DATE: April 18, 2018

**ADDENDUM NO. 1**  
**CITY OF PLYMOUTH**  
**CONTRACT DOCUMENTS FOR**  
**HWY 55 FRONTAGE ROAD RECONSTRUCTION**  
**CITY PROJECT NO. 13002**

UTILITY PLAN & PROFILE  
STA 0+00 - STA 9+10

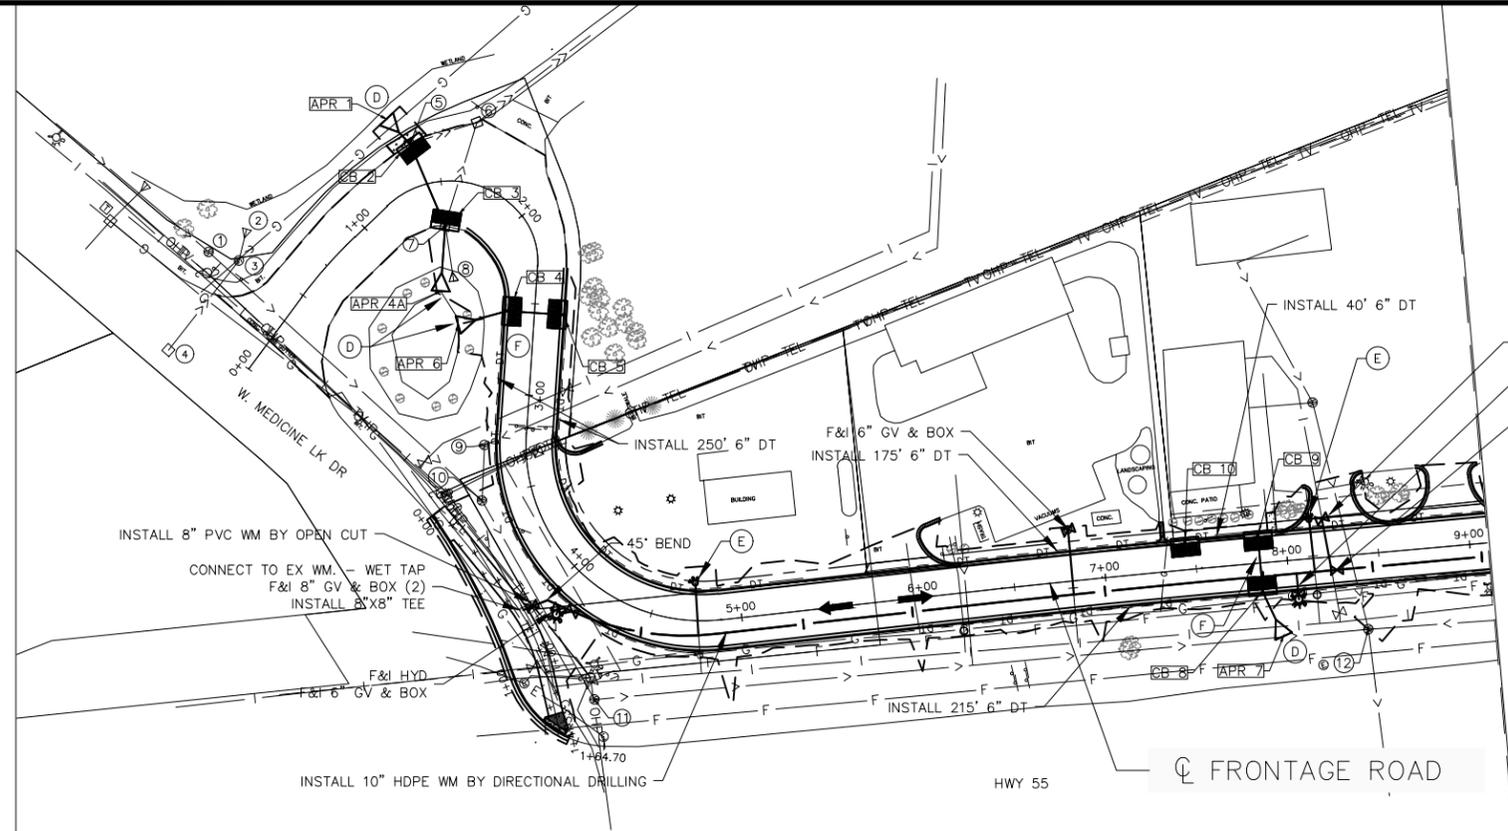
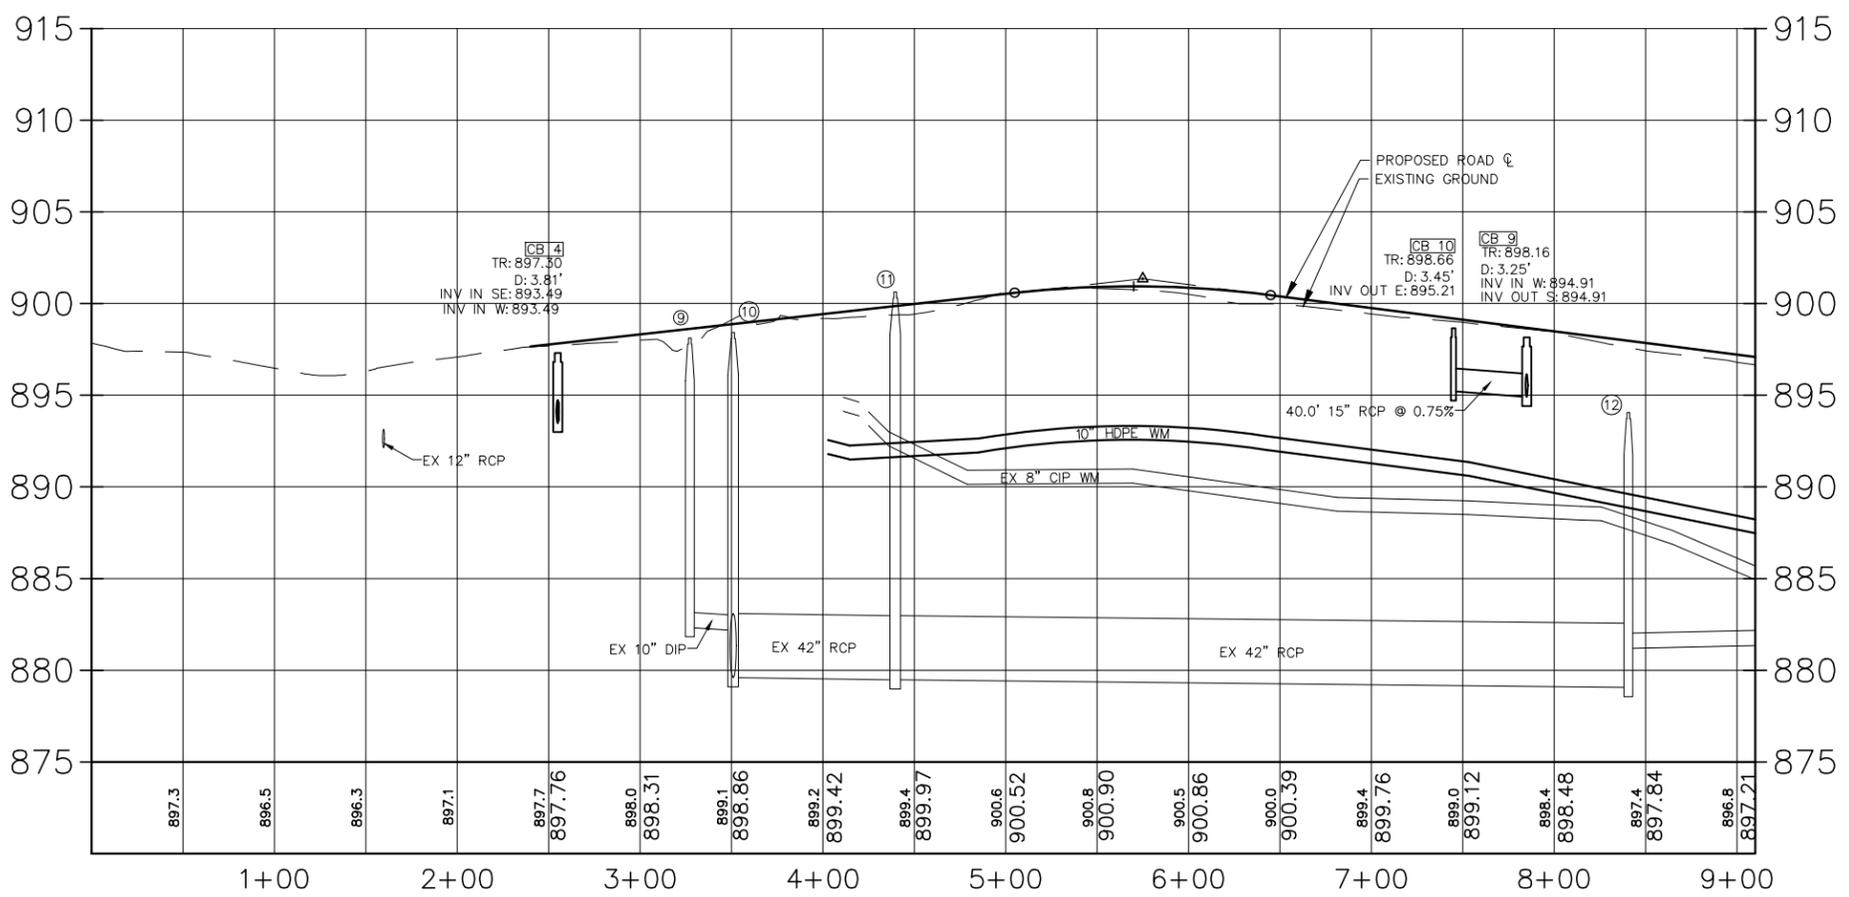
- a. The Contractor shall replace "Sheet 21 of 41" and "Sheet 22 of 41" with attached Sheets 21 and 22 identifying Revision 1. The following item was revised:
    - 1) Sheet 21: Gate Valve at Sta. 8+25 has been changed to a 10" Gate Valve.
    - 2) Sheet 22: Profile view of watermain at Sta. 14+00 has been updated to 8" PVC WM to match plan view

NO	DATE	BY	CKD	APPR	REVISION
1	4-18-18	MP	MP	MP	CHANGED SIZE OF F&I GV & BOX NEAR STA 8+25 FROM 8" TO 10"

UTILITY PLAN & PROFILE  
 STA 9+10 - STA 16+35.45

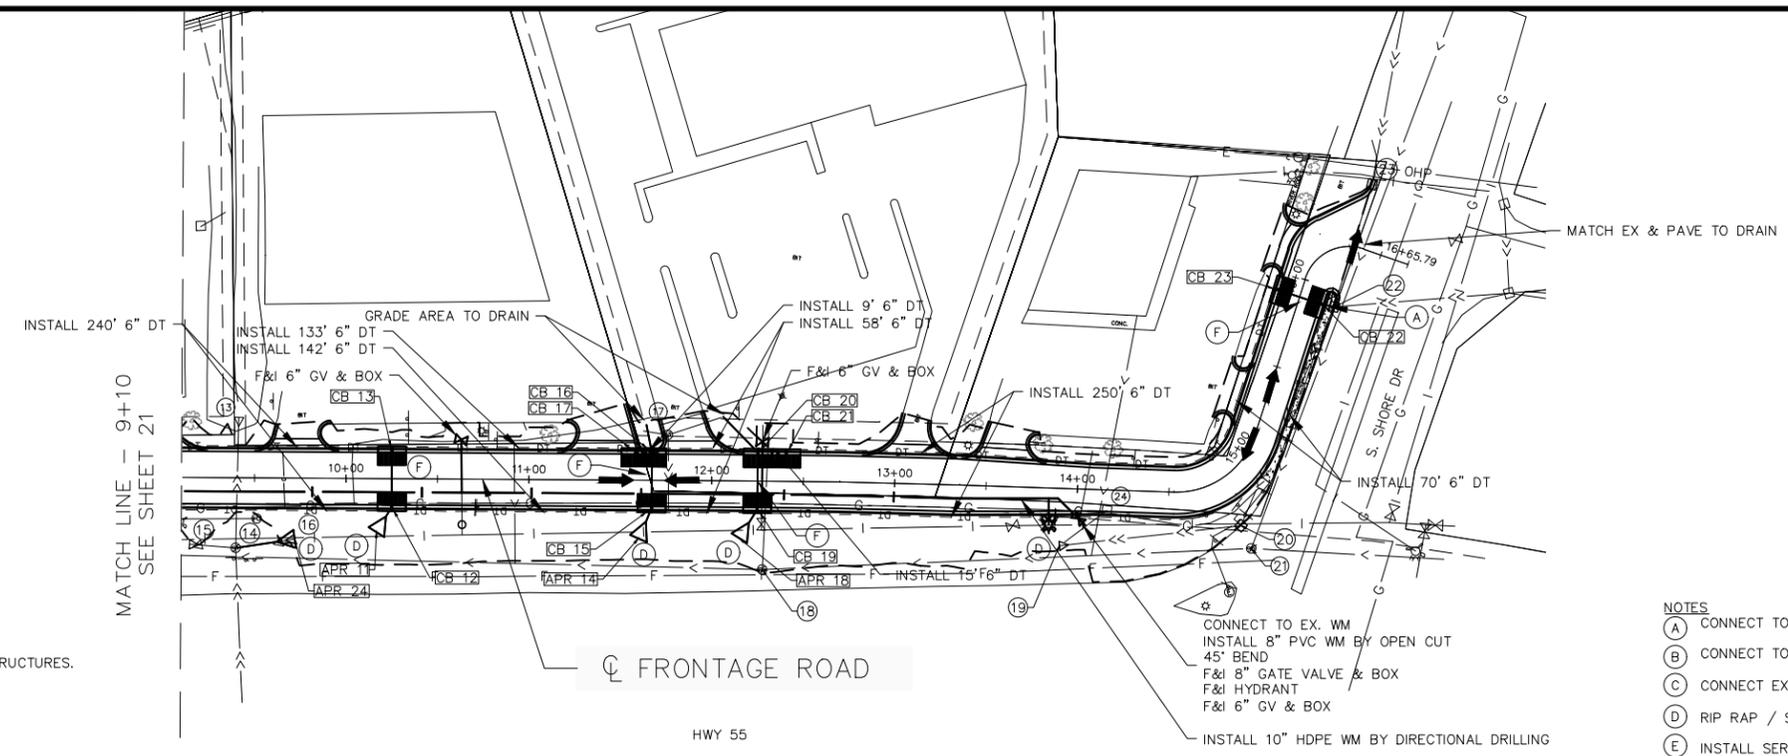
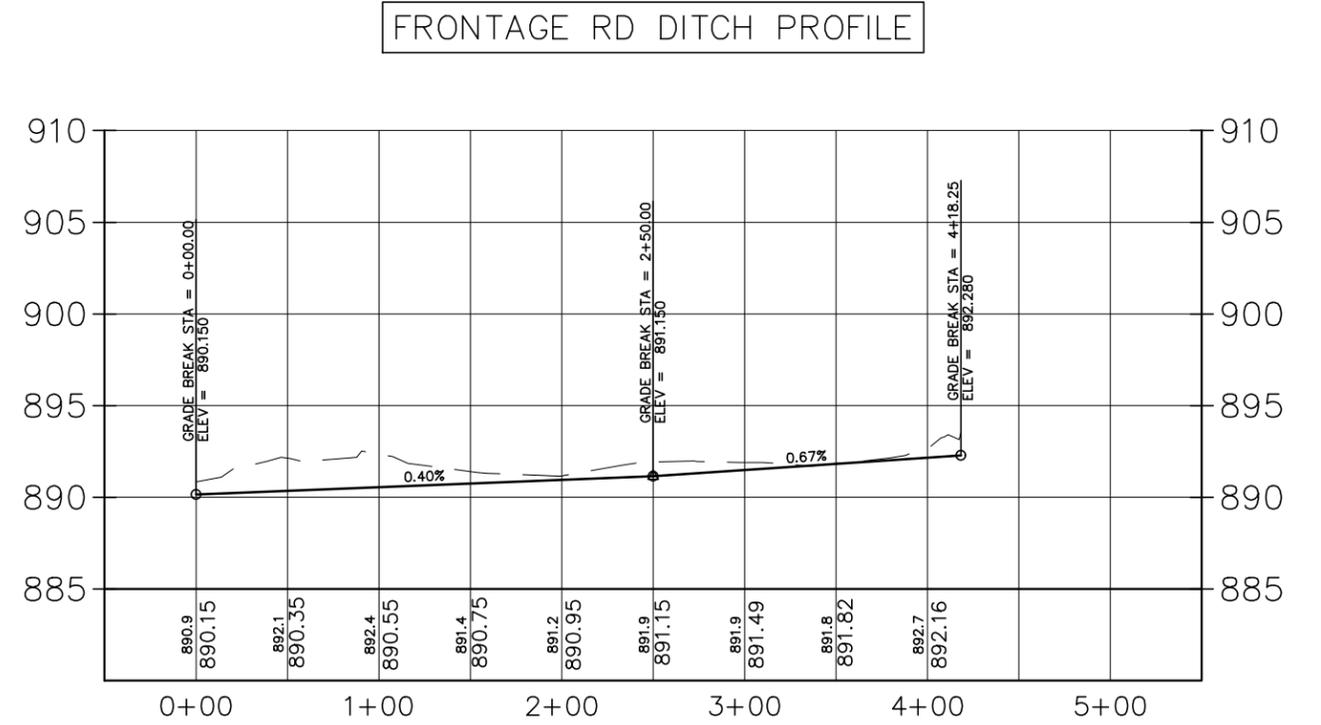
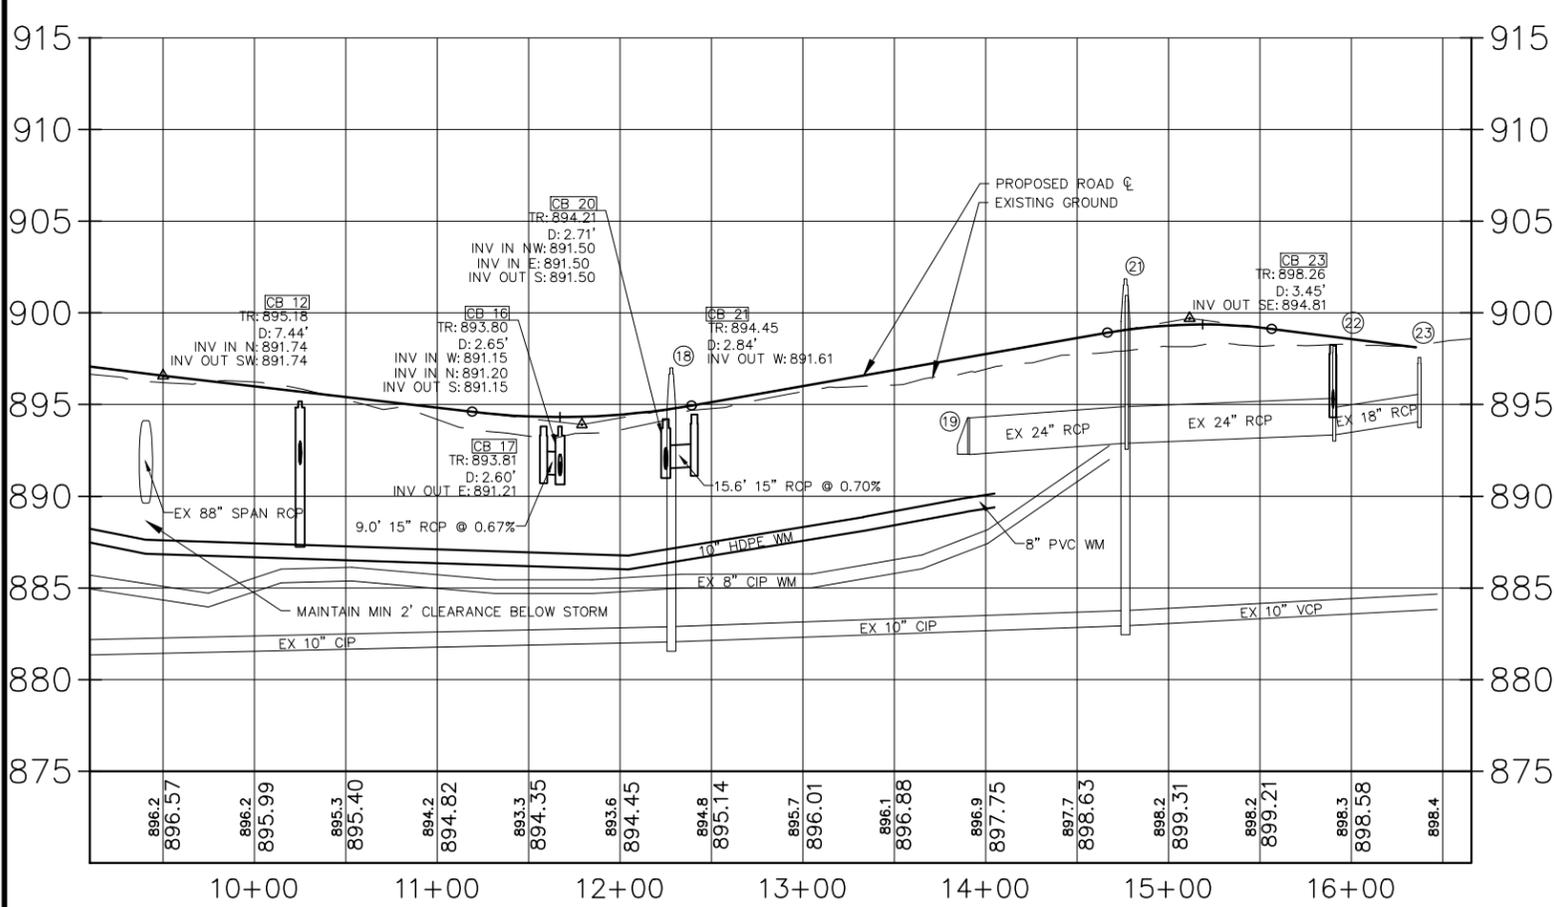
NO	DATE	BY	CKD	APPR	REVISION
1	4-18-18	MP	MP	MP	CHANGED PROFILE LABEL OF PVC WM FROM 10" TO 8"
